# UNITED STATES PATENT AND TRADEMARK OFFICE

APPLICATION NO.	FILING DATE	FIRST NAMED INVENTOR	ATTORNEY DOCKET NO.	CONFIRMATION NO.
10/714,367	11/14/2003	Gary J. Craw	18695-9318-00	1861
23409	7590	11/01/2005	EXAMINER	
MICHAEL BEST & FRIEDRICH, LLP			HAN, JASON	
100 E WISCONSIN AVENUE			ART UNIT	
MILWAUKEE, WI 53202			PAPER NUMBER	
			2875

<b>Office Action Summary</b>	Application No. 10/714,367	Applicant(s) CRAW ET AL.	
	Examiner Jason M. Han	Art Unit 2875

**Fig 1**

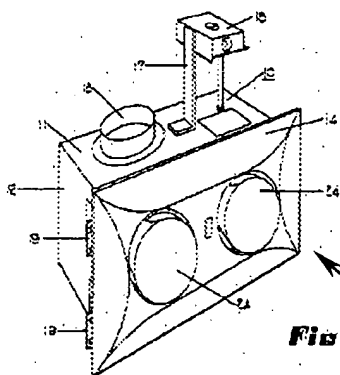
To elucidate: Applicant recites in Claims 11 and 32, or similarly, "positioning the lamp housing within the main housing to define a recessed lamp housing, the lamp housing having a portion extending outside of the main housing [Page 12]", and argues, "the cover plate 14 is not positioned within the housing 10 to define a recessed lamp housing [Page 12]". Though it is clear that Duhamel teaches a cover plate 14 not being positioned within the housing, the Applicant's above definition recited a portion of the lamp housing extending outside of the main housing, which accommodates the above teaching.

Note that the lamp housing [Figures 1&3: (14, 36)] is positioned within the main housing [Figures 1&3: (10)], but has a portion [Figure 1: (14); Figure 3: (36)] extending outside of the main housing.

**Fig 3**

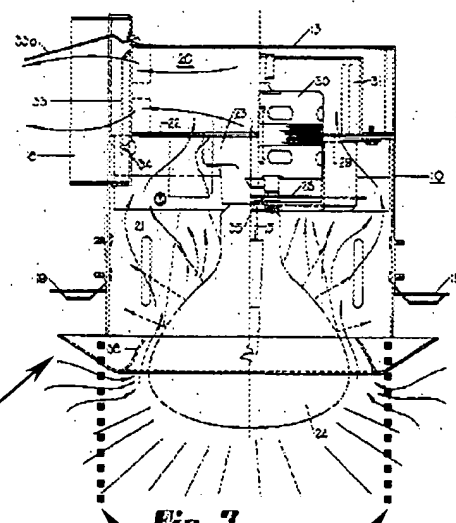
Note how the lamp housing (36) is recessed within the boundaries of the main housing (10).

Thus, as broadly interpreted by the Examiner [MPEP 2111], the prior art of Duhamel et al. (U.S. Patent 3692977) remains commensurate to the scope of the claims as stated by the Applicant.

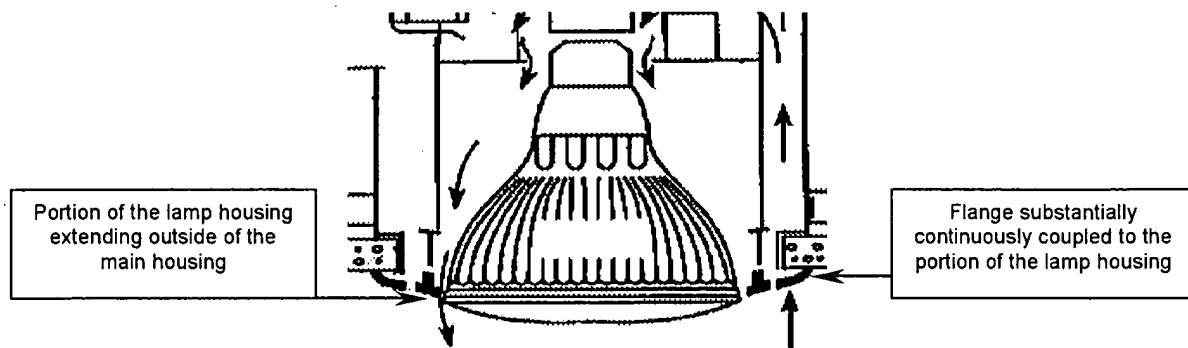
6. Claims 1, 3-4, 7-10, and 42 are rejected under 35 U.S.C. 102(b) as being anticipated by Hutain (U.S. Patent 6095671).

7. With regards to Claim 1, Hutain discloses a combination lighting and ventilating apparatus including:

- A main housing [Figure 2A: (108)] having a first aperture [Figure 2A: proximate (110)], wherein the aperture defines a ventilation inlet and a lighting outlet;

- A lamp housing [Figure 2A: (122)] recessed within the main housing, wherein the lamp housing has first [Figure 2A: (150a, 150c)] and second [Figure 2A: adjacent to the lamp] apertures spaced a distance from one another, as well as a portion extending outside of the main housing;

- A lamp [Figure 2A: (174)] recessed within the lamp housing and the main housing;
- A fan [Figure 2A: (FAN)] positioned to draw air into and through the first aperture of the lamp housing, around the lamp, and through the second aperture of the lamp housing; and

- A flange [Figure 2A: (126)] substantially continuously coupled to the portion of the lamp housing extending outside of the main housing, whereby the flange substantially continuously engages a surface of a structure [Figure 2A: (4)].

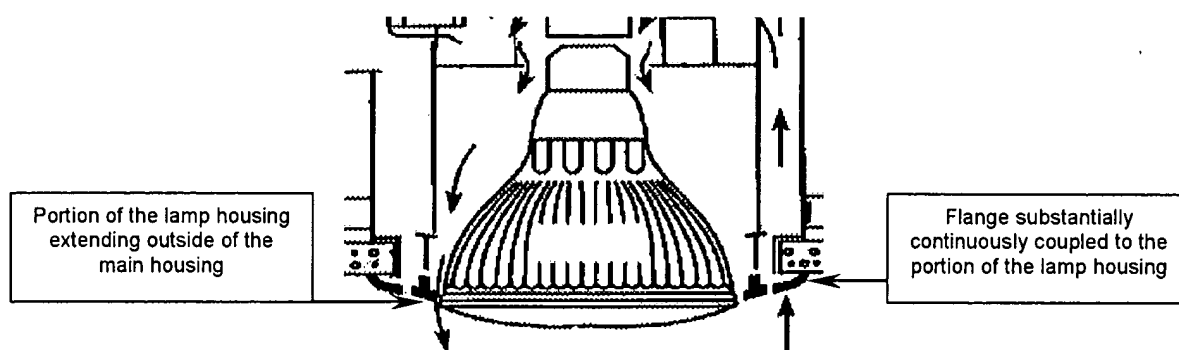
passageway [Figure 2A: (135)] through which air passes from the first aperture of the lamp housing to the second aperture of the lamp housing and into the main housing.

14. With regards to Claim 42, Hutain discloses the lamp housing [Figure 2A: (122)], the flange [Figure 2A: (126)], and the surface of the structure [Figure 2A: (4)] concealing the main housing [Figure 2A: (108)].
